Anacortes City Council
Municipal Building Council Chambers
904 Sixth Street

6. **Public Hearings**
 - a. * Open Record Public Hearing, SPL-2015-0006, 38th Street Short Plat, Appeal of Administrative Decision (Discussion/Possible Action)

SHEET NO.
3 OF 4

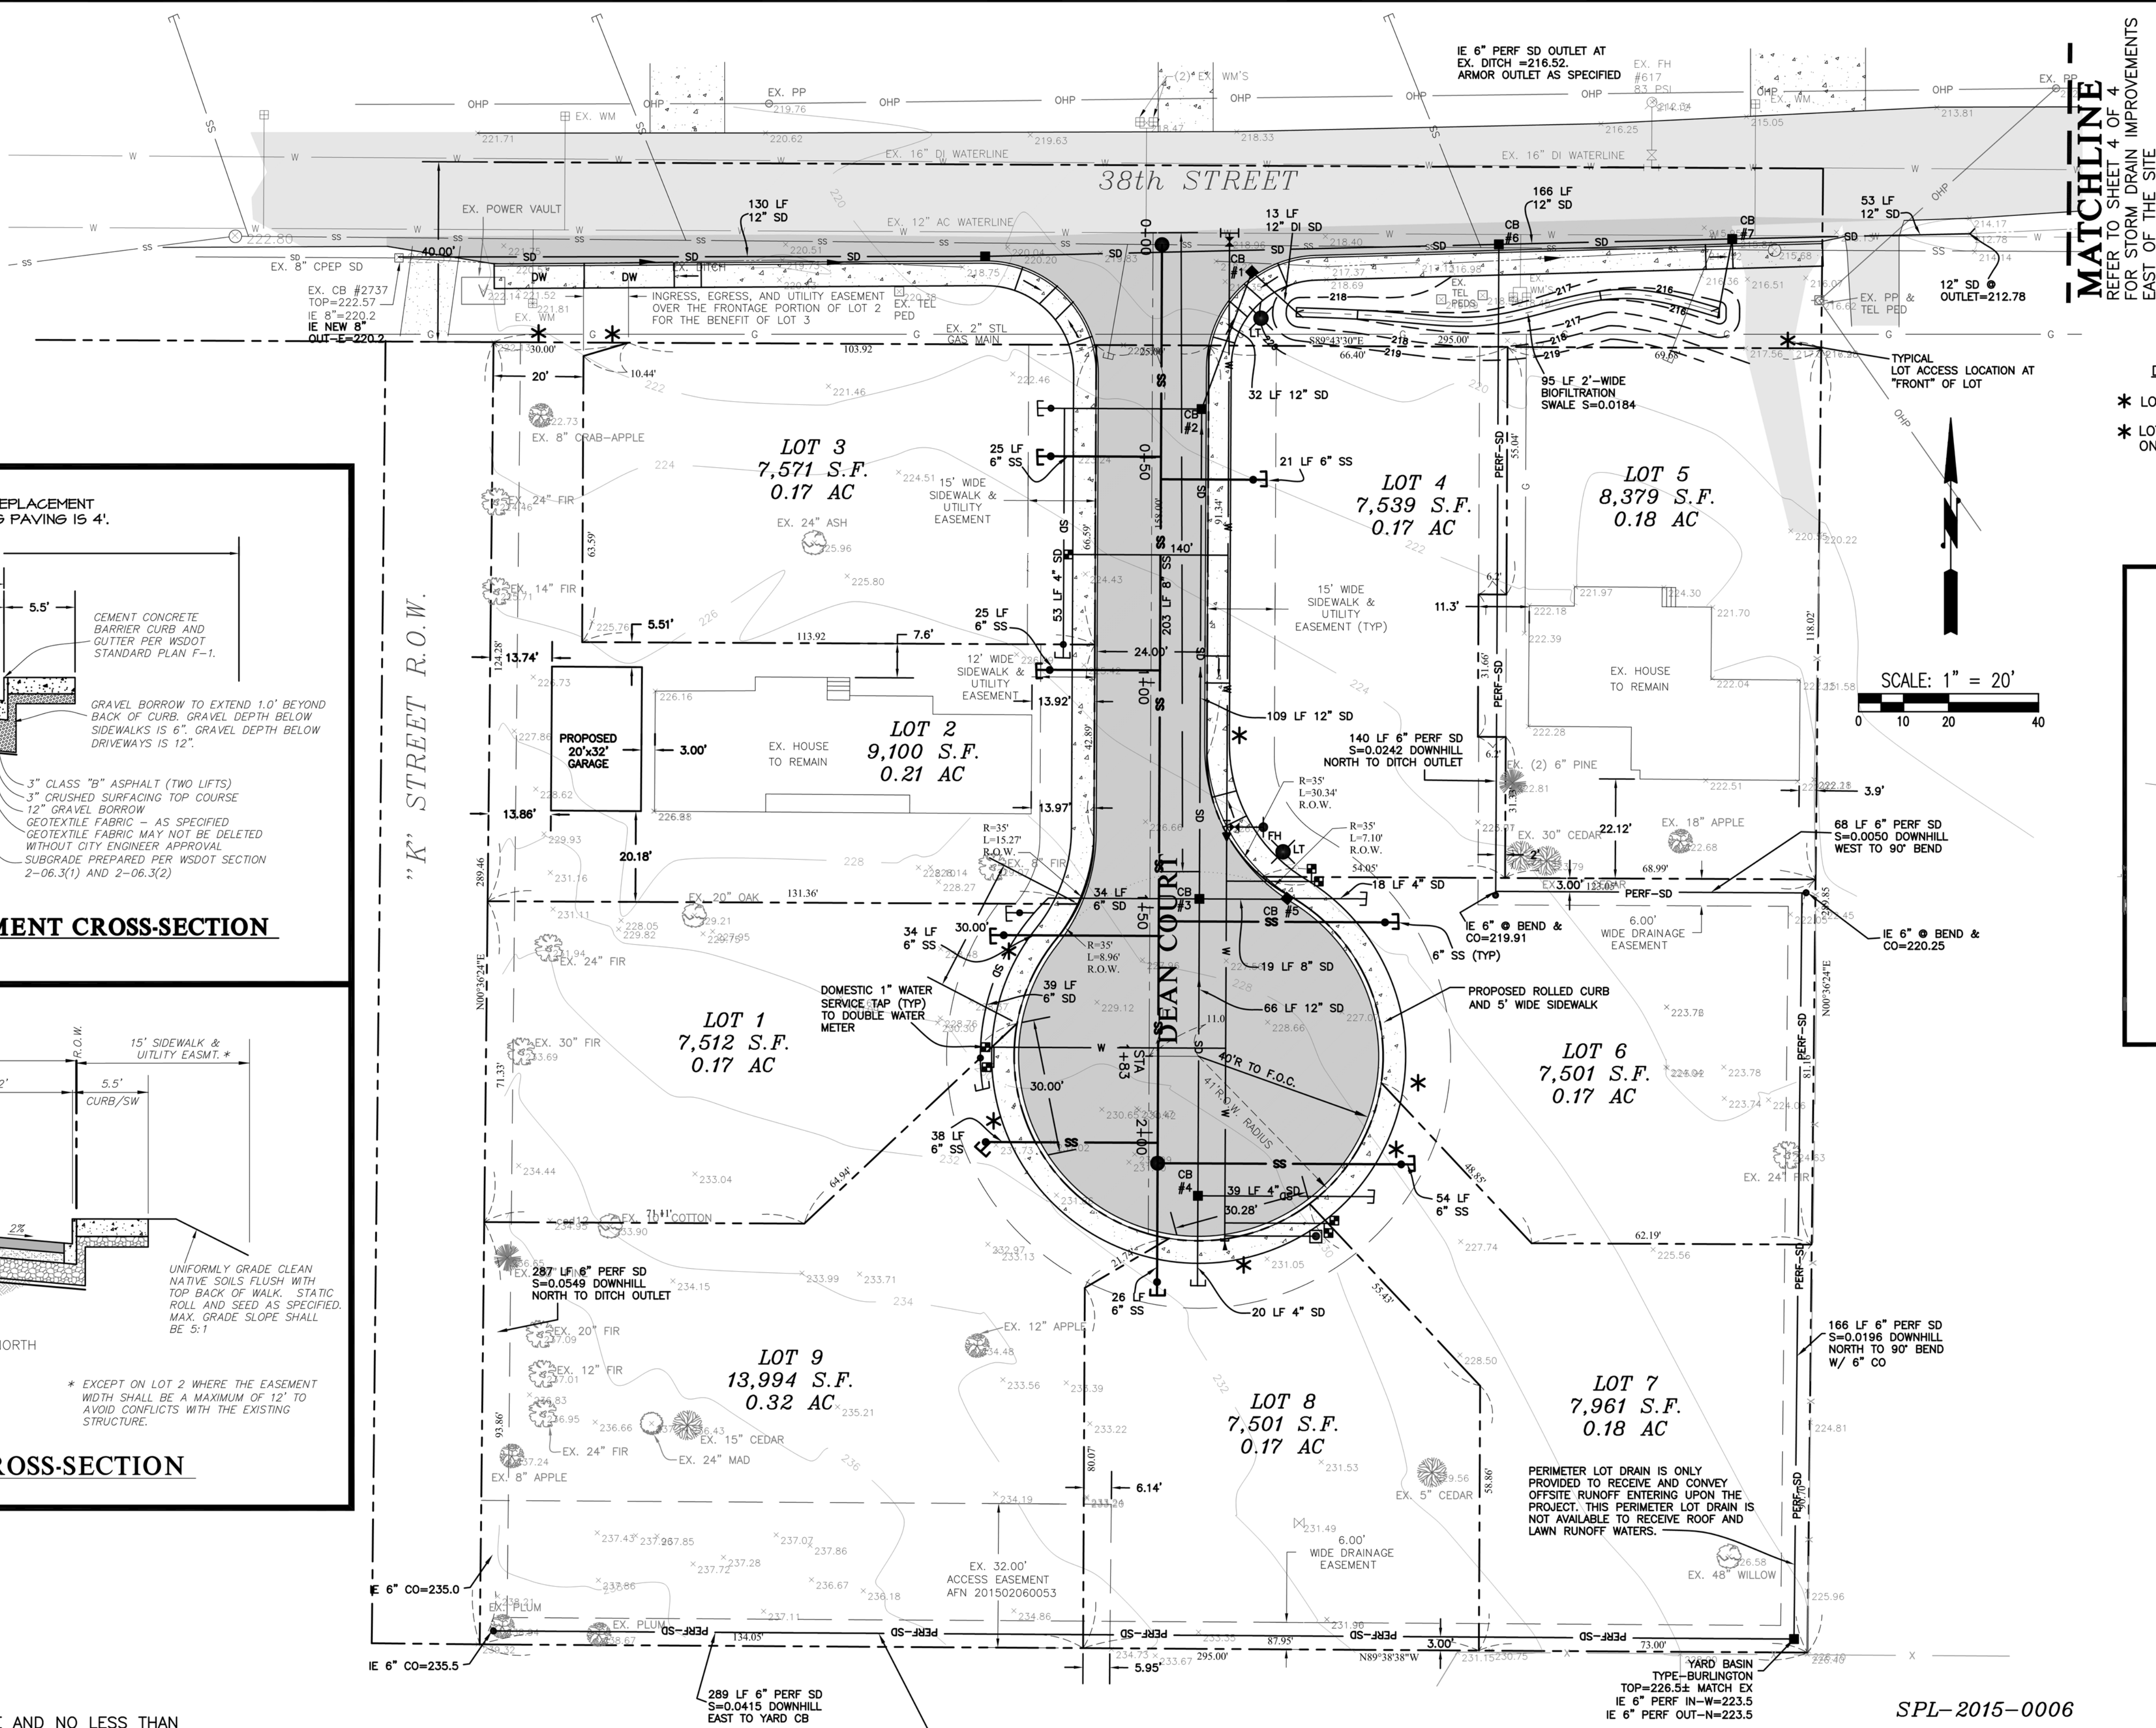
Sheet 3 of 3: Identify property accesses and how the off-street parking will be taken care of. See Public Works memo, under Streets regarding Lot accesses.

Sheet 3 of 3: Show two street lights to be installed. One in the Cul-de-Sac and the other at the intersection of Baughn Lane and 38th Street. This was identified in the Public Works memo.

Sheet 3 of 3: Since there is discussion about splitting Lot 9 into two lots in the future, will there be a 3rd meter installed with provisions to access without disturbing any infrastructure?

Sheet 3 of 3: All private sanitary sewer side service stubs in the Public Right-of-Way shall be 6-inch, per the EDS Standards, Chapter 5, Section S1-10 Side Sewers.

Sheet 3 of 3: All existing overhead utilities shall be converted to underground to the existing homes.

Sheet 3 of 3: Storm drainage will be worked out at Civil Construction plan submittal. A reduction in pipe and structures can be made to achieve the same as shown.

SHEET 2 OF 2

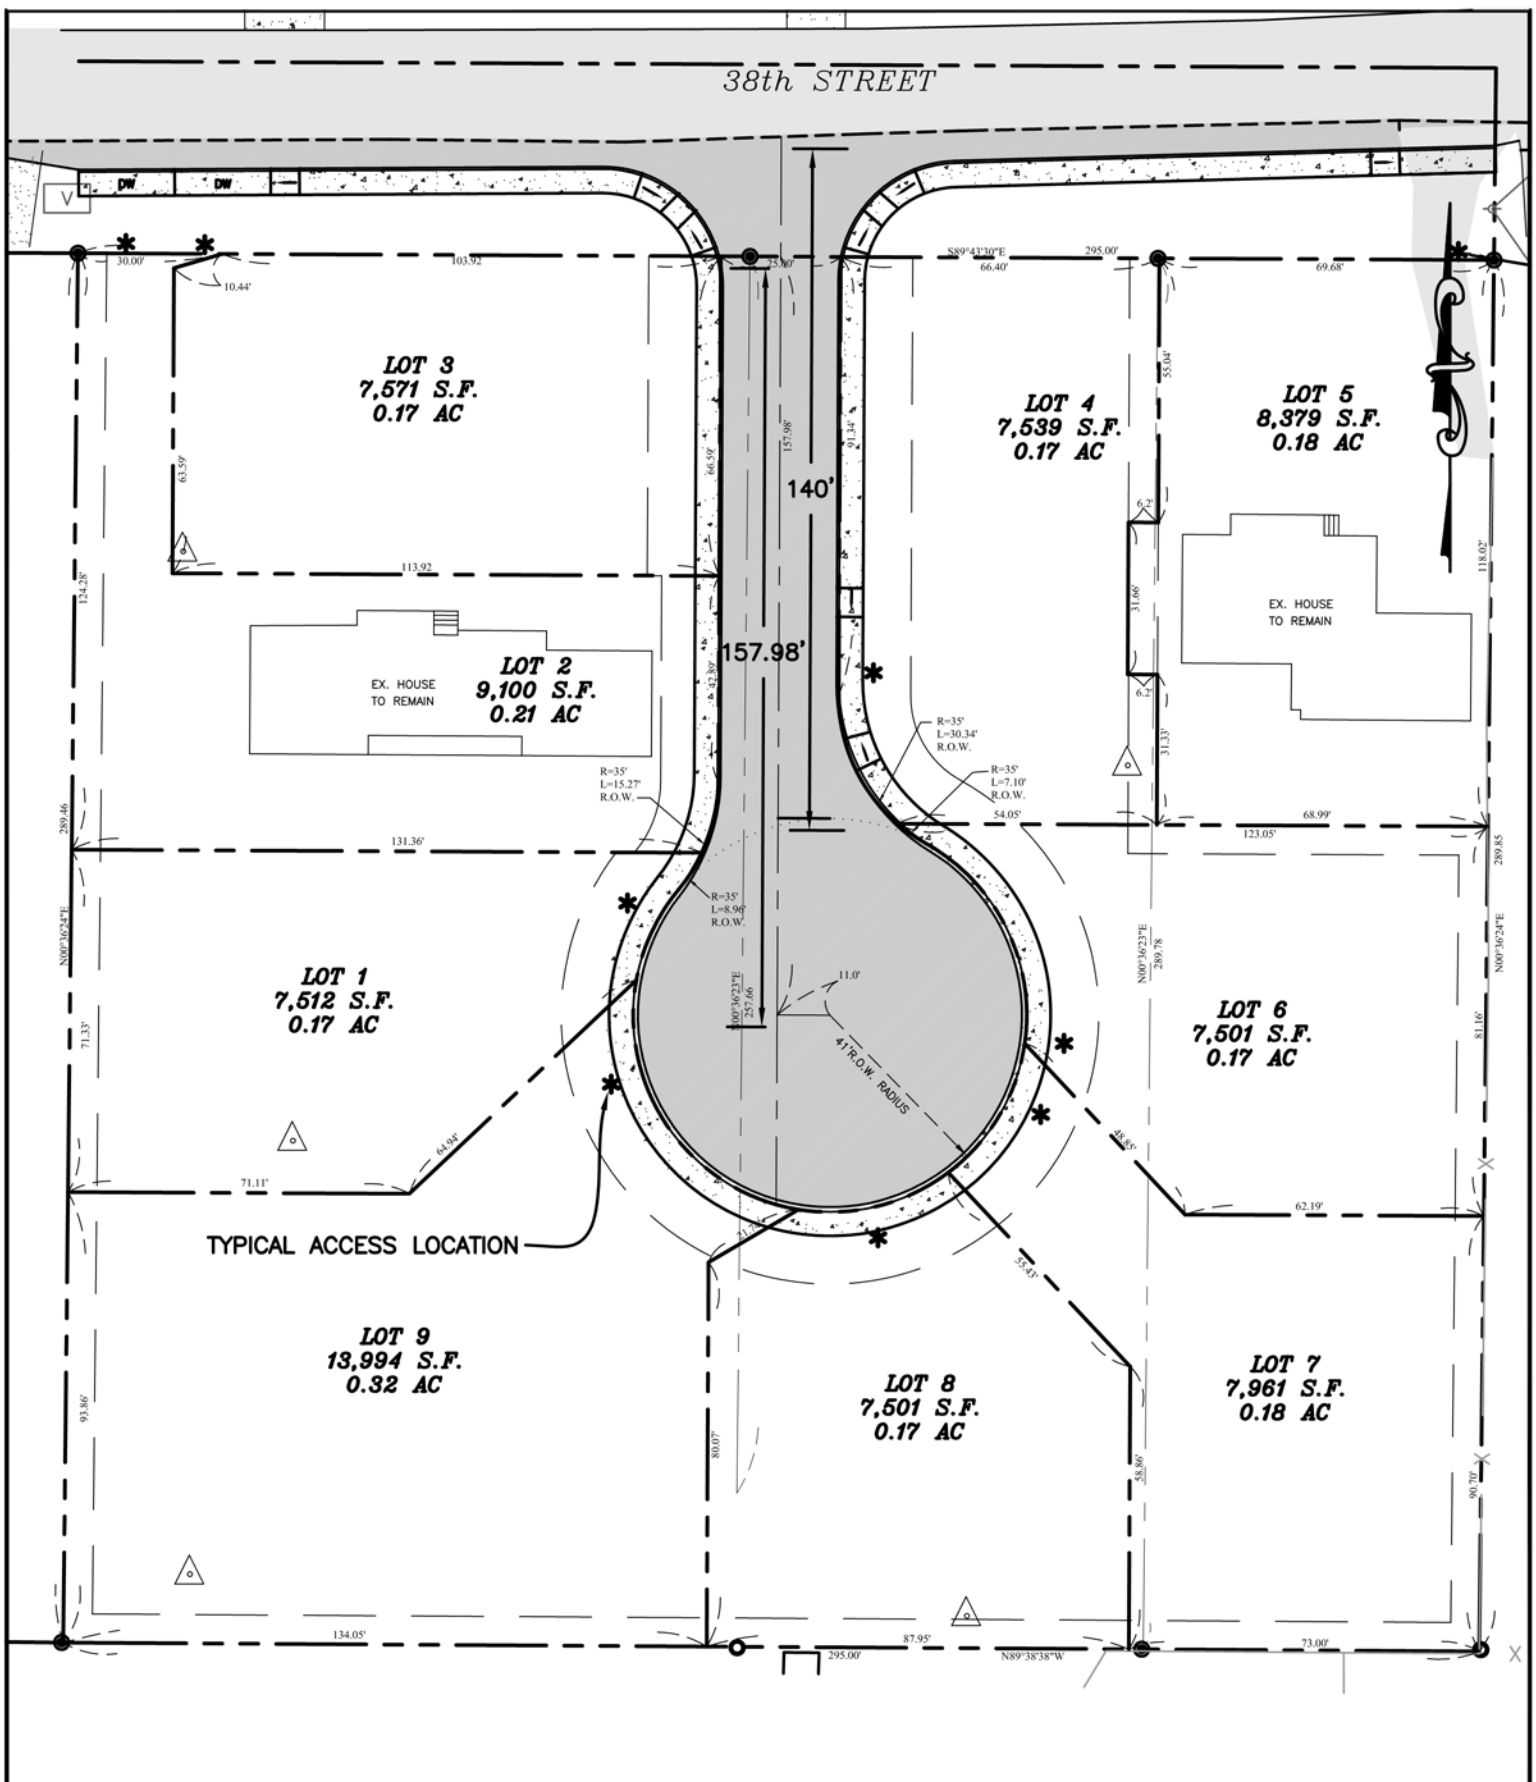
9. On sheet 2 of 2, please include an accurate legal description of the land involved in the subject short plat.

Item A.4.: A legal description was not provided in the Short Plat for review. Unless it is on Sheet 2 of 2, which is not part of the routed submittal.

Response: *The legal description for this project is shown on sheet 2 of 2 of the Short Plat Map.*

Response: *A legal description is located on sheet 2 of 2 of the Short Plat Map.*
